Nonconformance Report

Space Science & Engineering	Lab					
Subsystem	Part/Document Name			No. of NCR Sheets		
EPS		FISCE Solar Panel Schematic and Layout				
		Brief Descr	iption			
During initial EDU testing on the FISCE solar panel, odd behavior was observed on the Q23 transistor. This transistor is a dual NPN/PNP type FMB2227A BJT. The NPN gate of Q23 is used to pull the TRIG pin of the 555 timer LOW with a series of pulses from the MCU. It was observed that the TRIG remained in its default HIGH state even though the correct pulse signal from the MCU was driving the gate. Because of this, the load never turned on.						
MPS Nur	nber	MPS OP Number		Hardware Type		
			□ Flight □ Non-Flight	□ Flight Qu ☑ ETU	alification	
Quanti	ity	Procedure Number		Found During		
				FISCE Test Plan		
		Reference Doc	uments			
FB-E-4007	-D, FB-E-4008	3-D (see FISCE_Documenta	tion.zip on Knowled	lge Tree pending relea	ases)	
	A	nalysis (Attach additiona	al pages if necess	ary)

Proposed FISCE board modifications. RED lines indicate cut traces, GREEN lines indicate suggested fly-wire attachments.

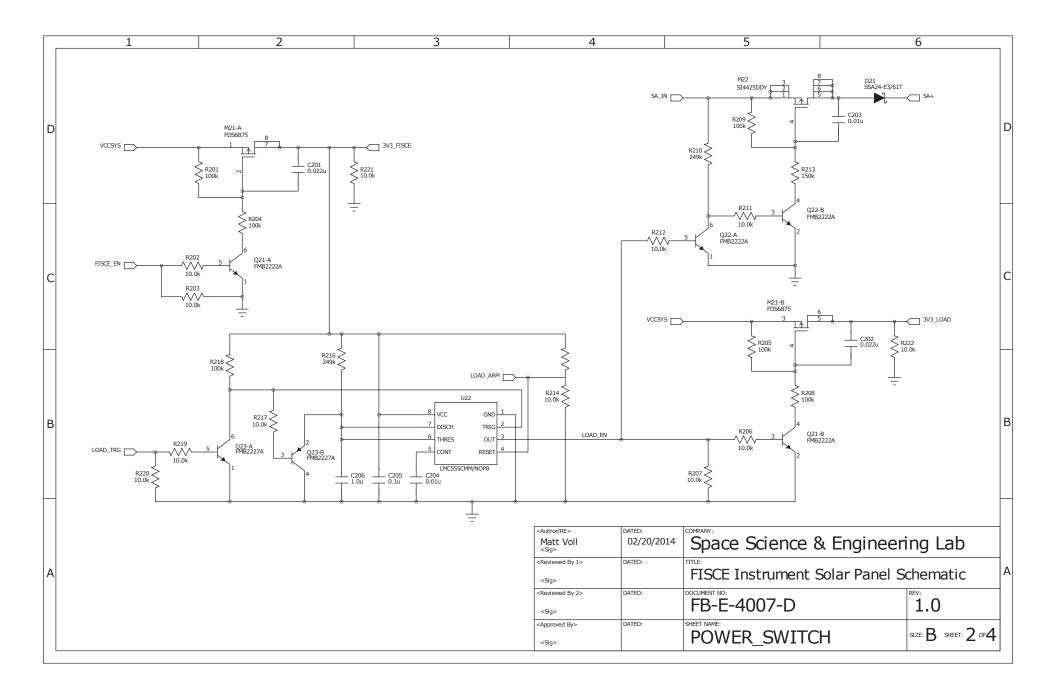
Proposed Corrective Action					
There is a total of 6 pins on the FISCE board that are connected incorrectly in the layout of the circuit. These are all low-current control signals located on SOT23-6 packages. The proposed action is to attempt to cut the 6 traces in the PCB and solder small gauge fly-wires between each of the pins and their correct connection point. Conveniently, each pin has a resistor nearby that may act as viable solder point for the fly-wires. See the attached schematic sheet and FMB2222A/2227A datasheets for details on the pin discrepancies. The alternative action would be to make the changes in the layout and spin a new set of 4 FISCE PCB's. This may delay our shipment to Vanguard of the completed/tested boards by at least a week.					
DE	D 1.	D /	DM		D /
RE	Discipline	Date Corrective A	PM Action Taken		Date
QA		Date	PM		Date
